**RE: Response to Comments**

**The Aurora Highlands Lennar Phase 1 – Site Plan – First Review**

**Application Number: DA-2062-61**

**Case Numbers: 2024-4018-00, 2024-3038-00**

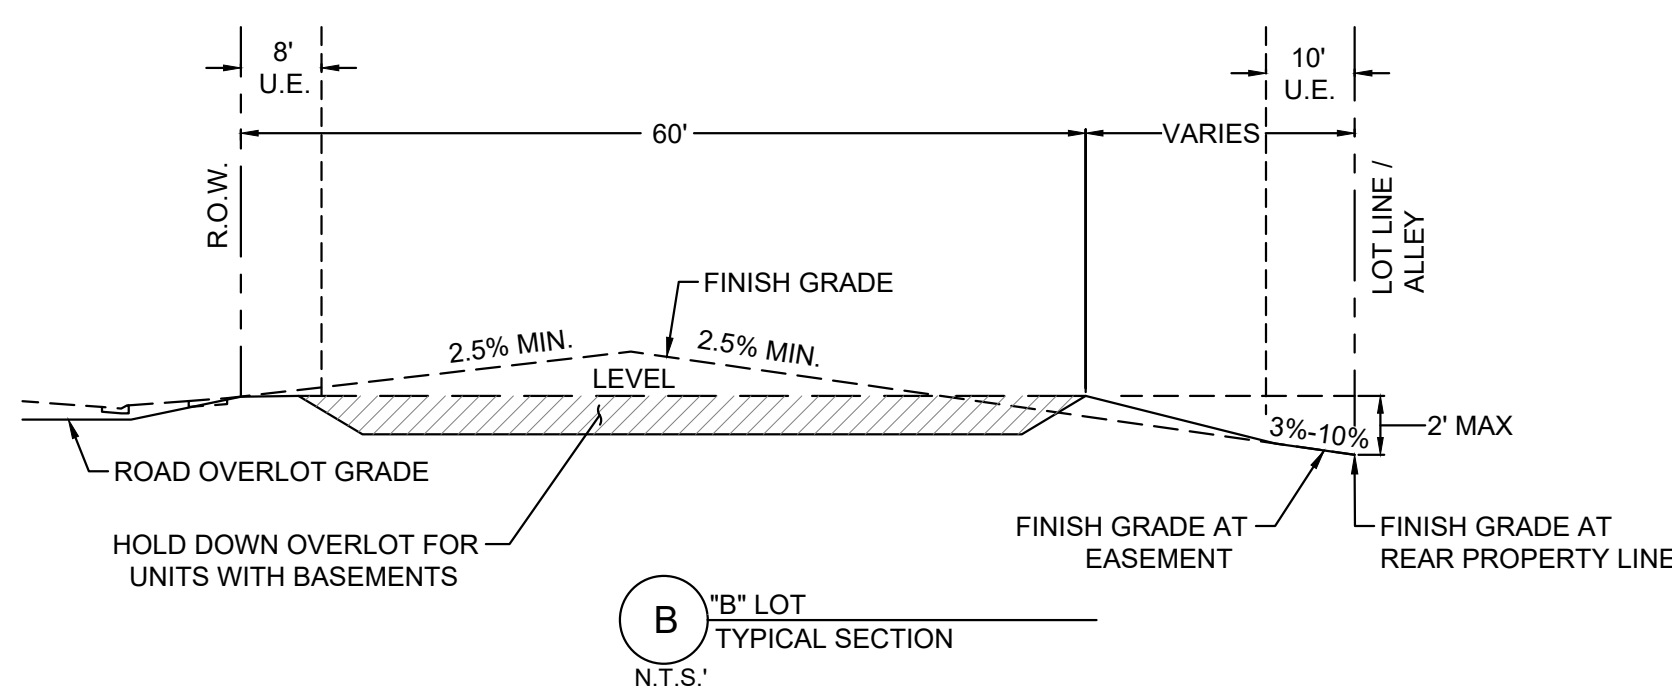
3J. Revise the Lot Dimensional Table per the redlines.

Information has been fixed for this lot dimensions table

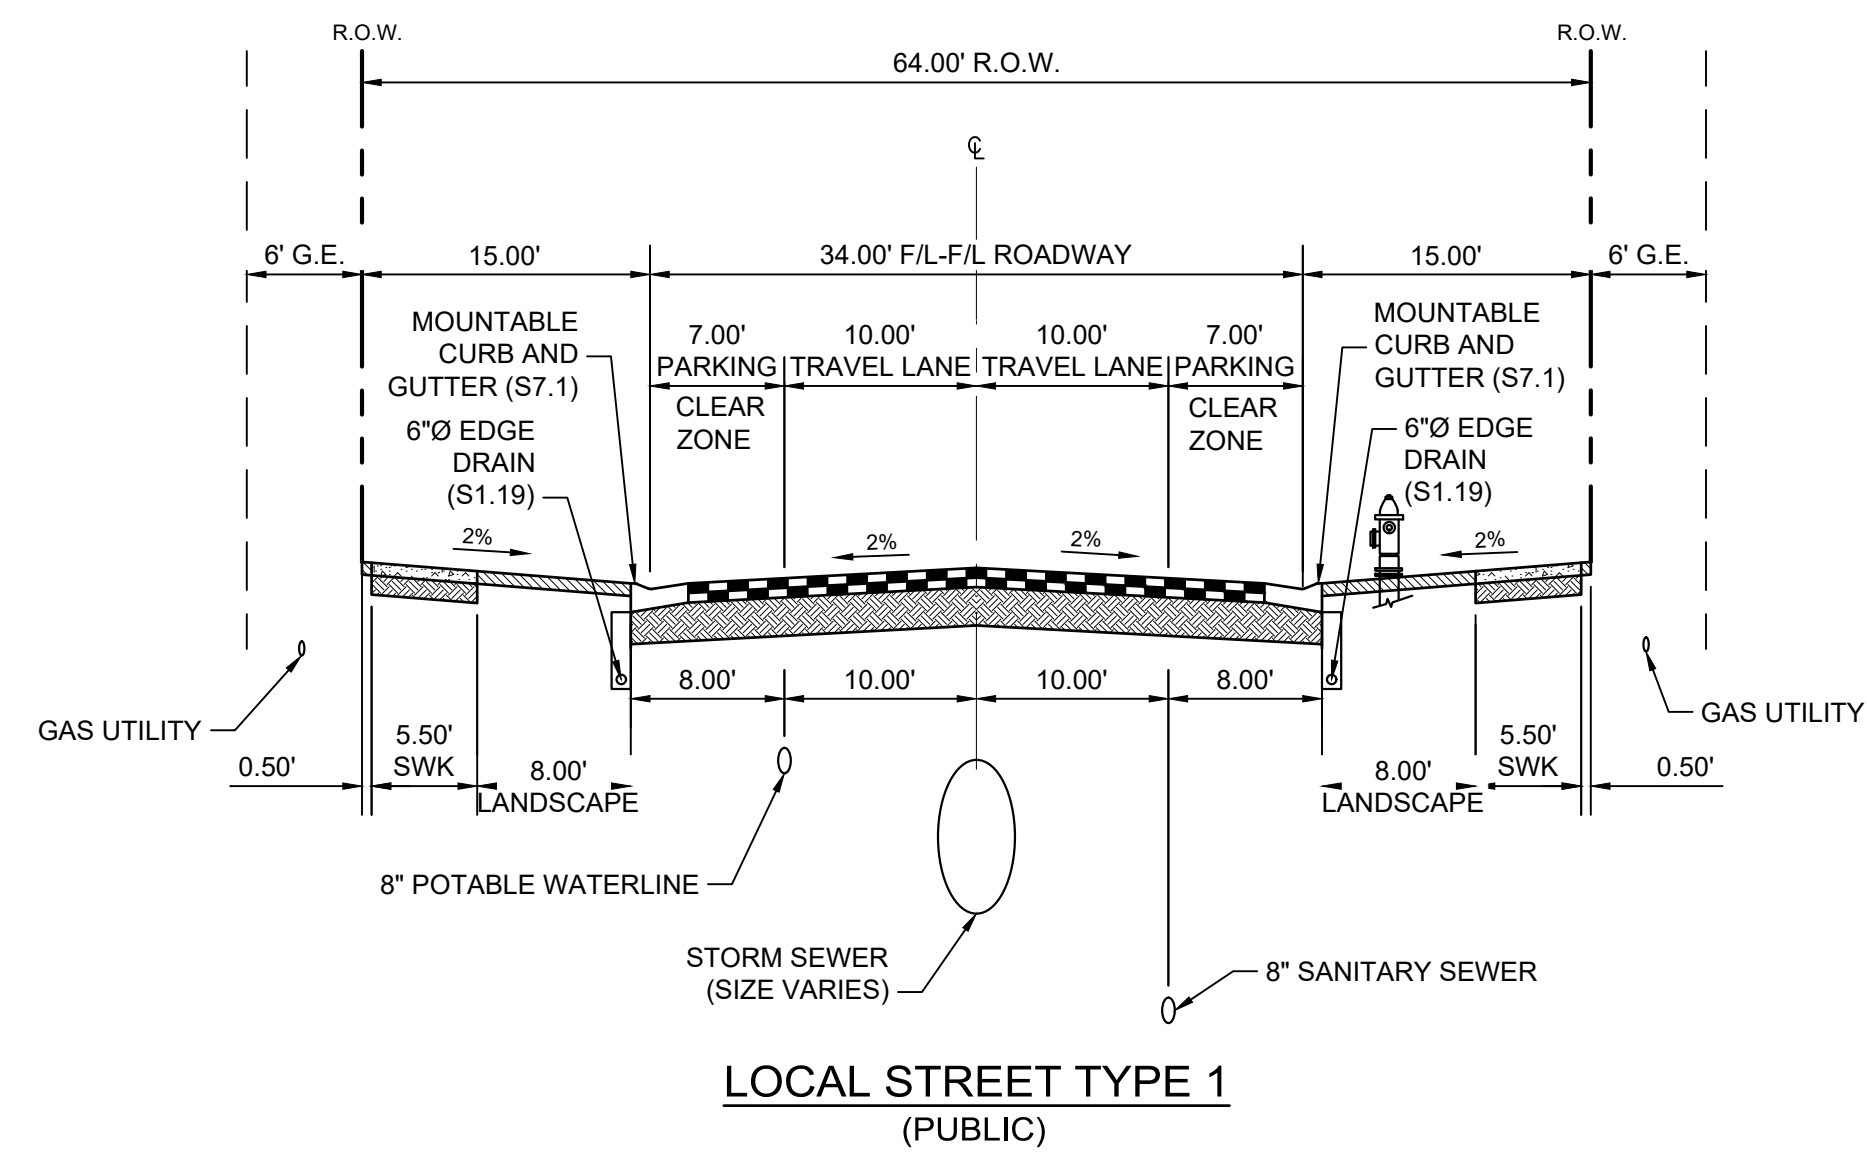
Need a separate typical section for the private road H & J

Add a section for the Loop Lane

Loop lane section has been added.

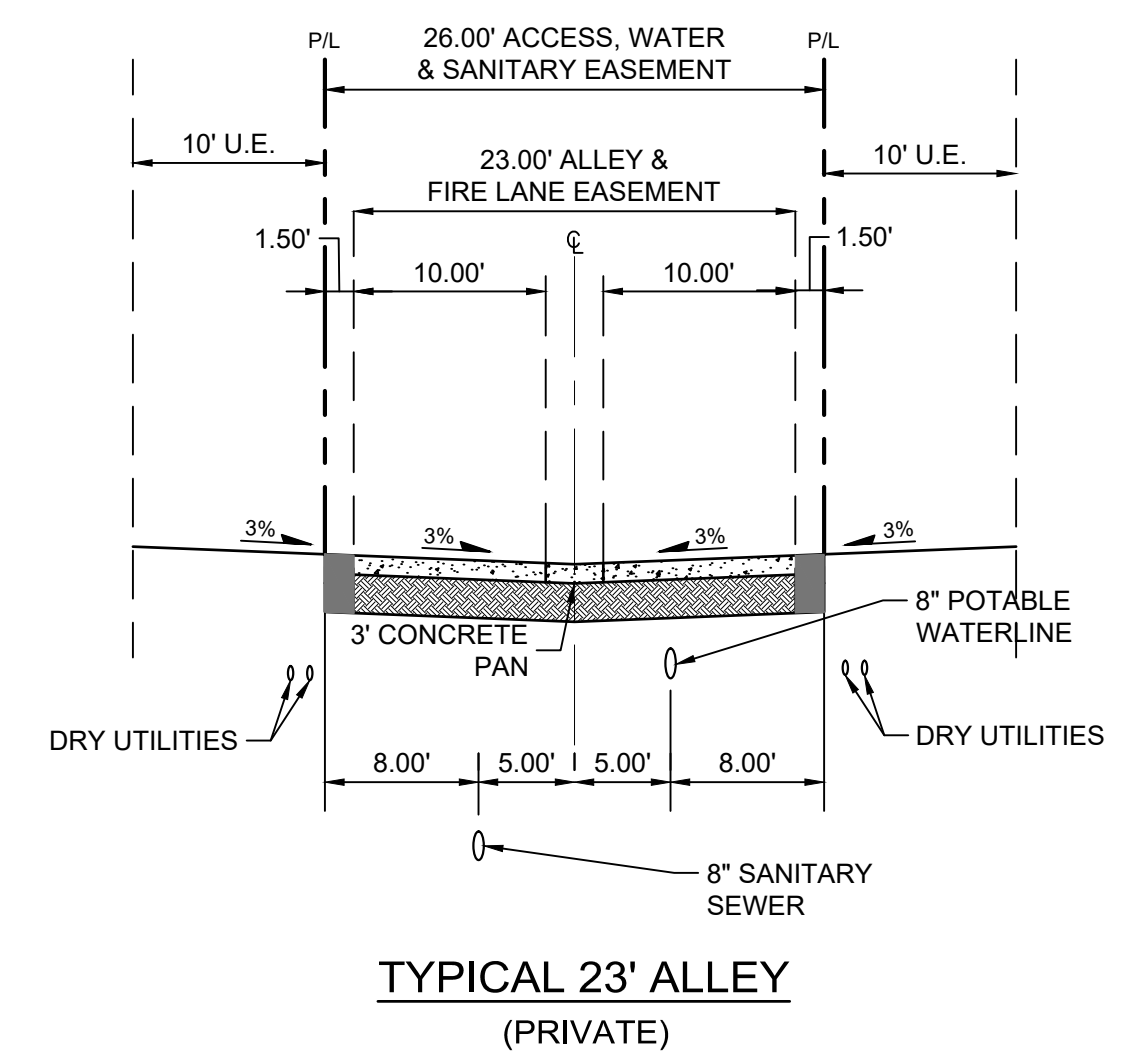
Include the roadway names for the public street

Roadway names have been included in the detail.

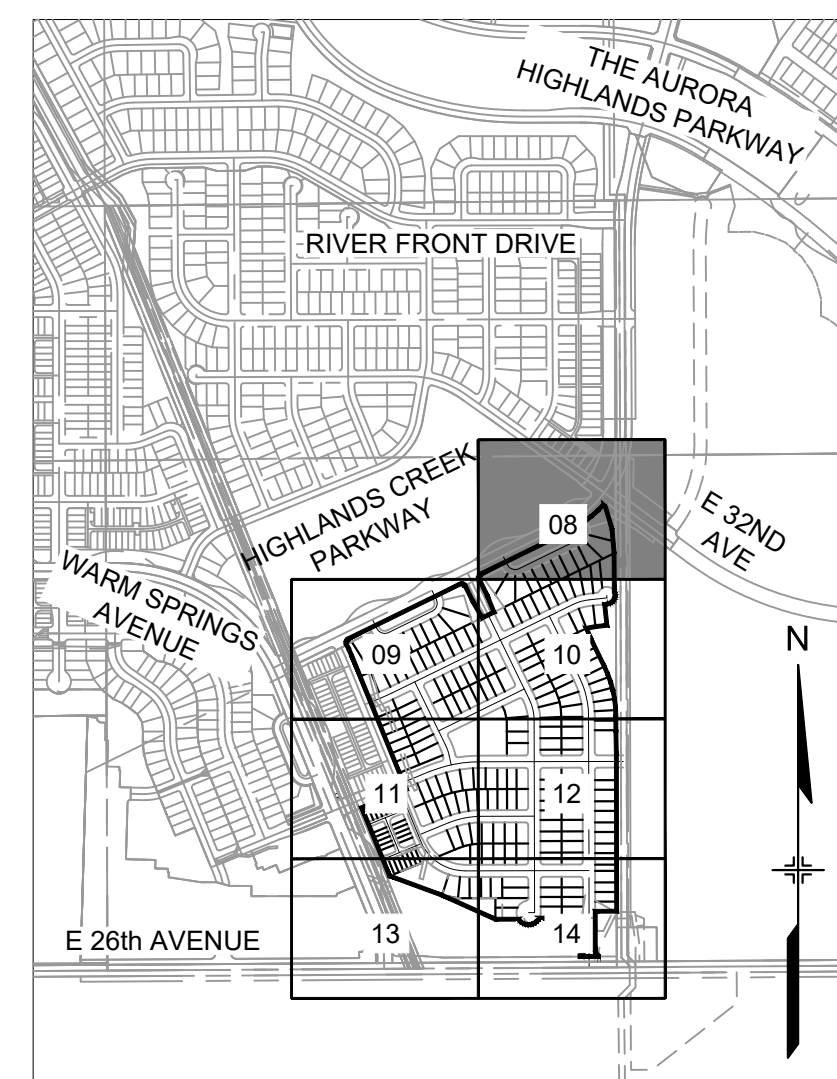
is this the ROW line?  
fix alignment and/or show sidewalk easement

is any fencing included in TAH PP #9? Show and label.  
Proposed fencing is shown in the legend.

provide a section for the loop lane  
Section for loop lanes has been provided.

***Response: Directional arrows have been added to the adjacent streets. The ROW on the east side of road J goes farther south and a normal section does. Meaning a sidewalk easement is not required as the sidewalk is still in the ROW.***

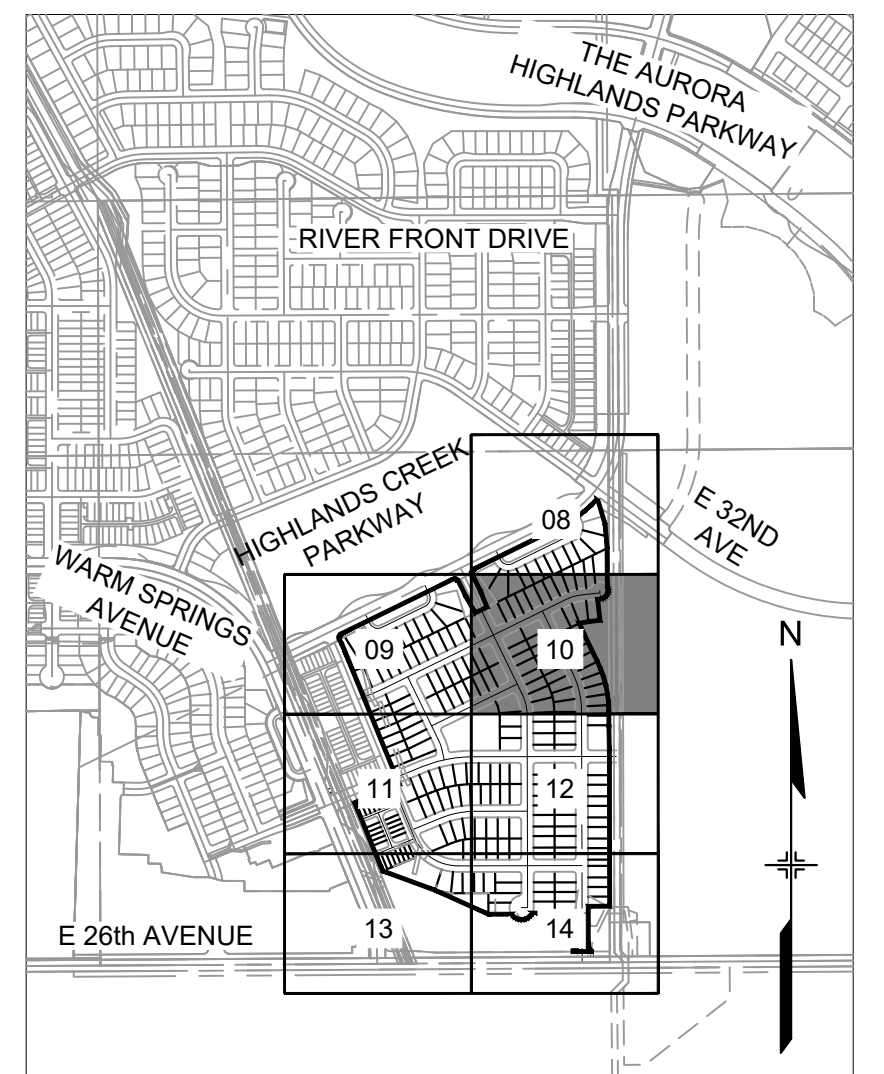
this road should  
be stubbed for  
future connection  
to the east.

Easement labeled  
and trimmed.  
Label Easement &  
if U.E. trim out of  
exclusive G.E.?

Trim U.E. out of  
exclusive G.E.?  
(Typical)  
Easement  
trimmed.

Road has been  
stubbed for future  
connection.

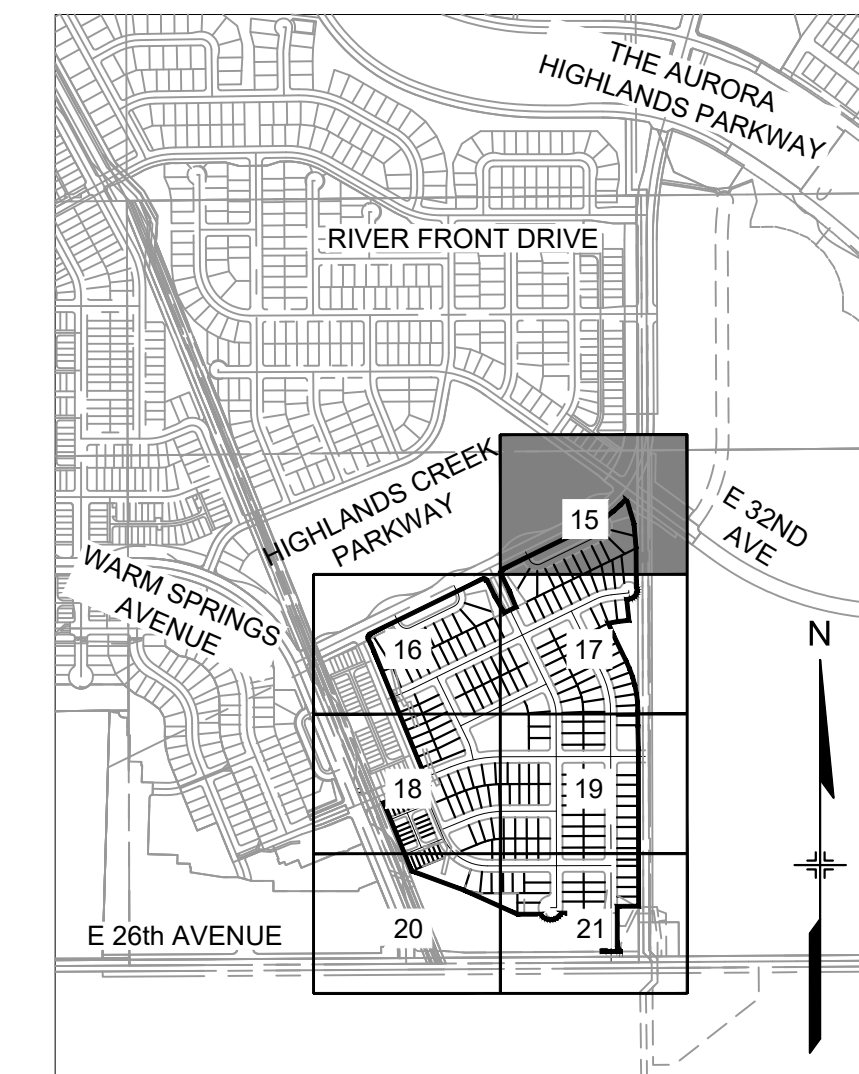
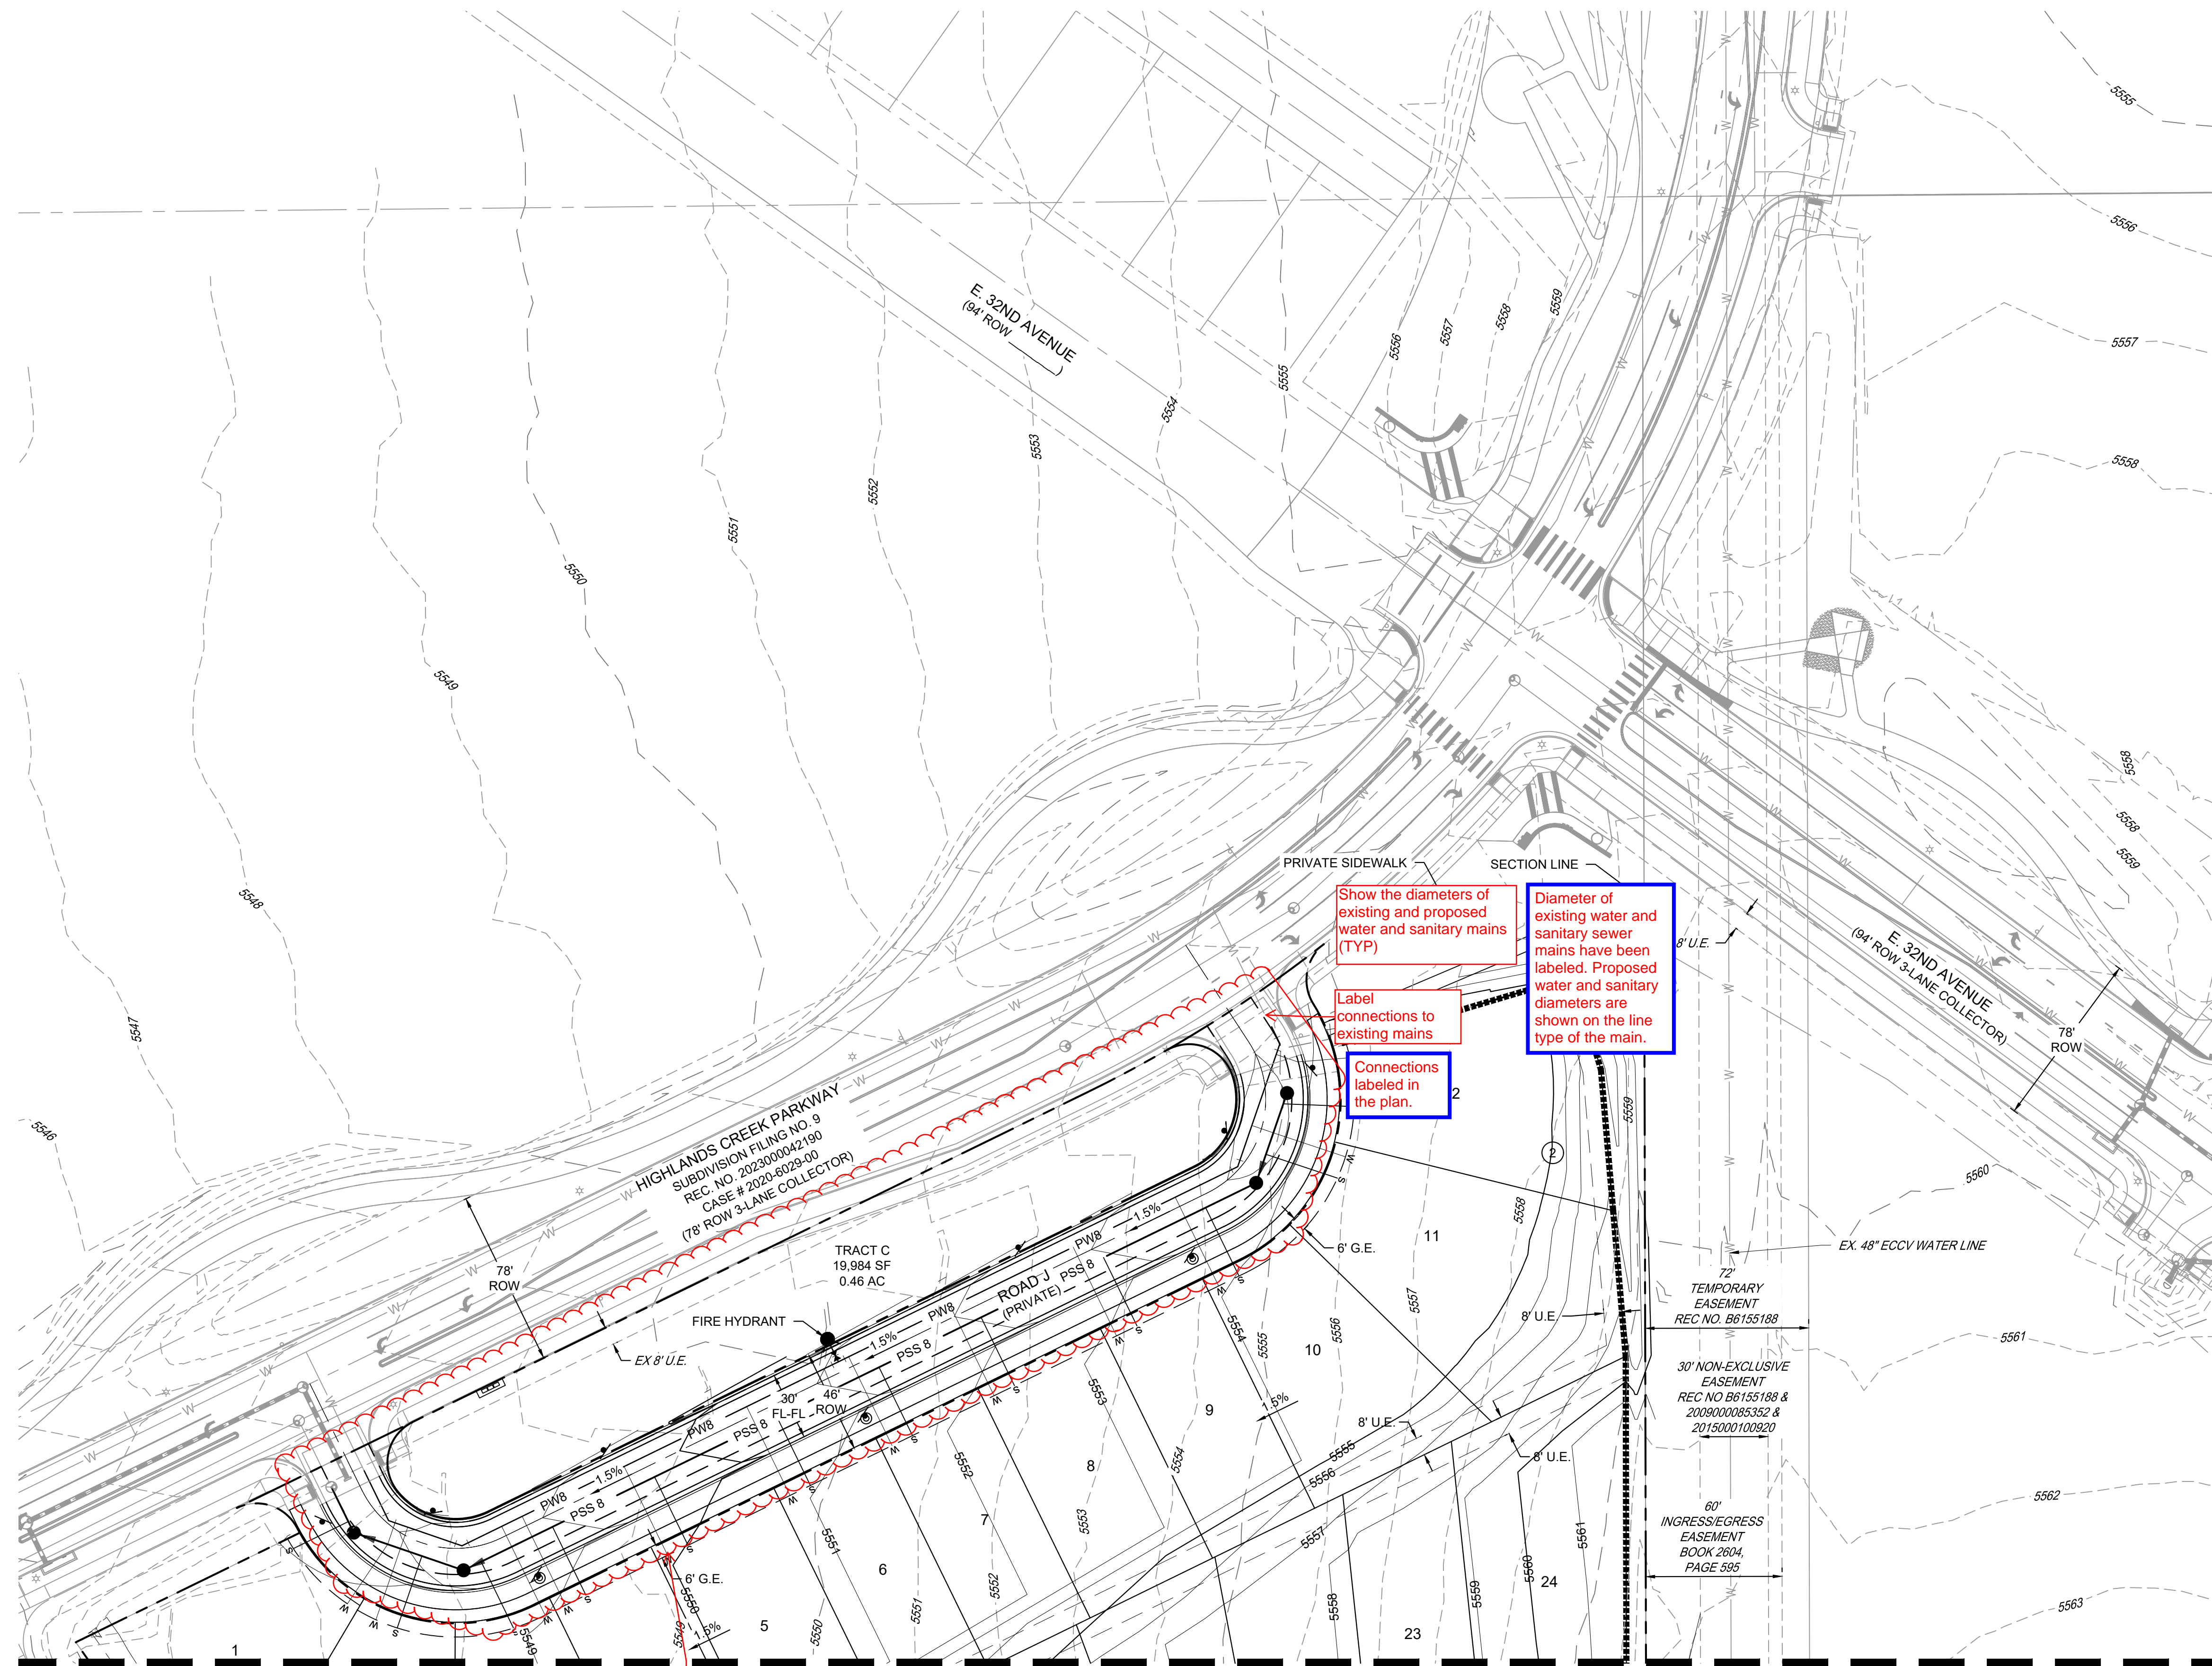
add reception number TYP all existing easements

Trim U.E. out of exclusive G.E.?

Easement trimmed.

E 27TH AVE. STREET NAME HAS BEEN ADDED.
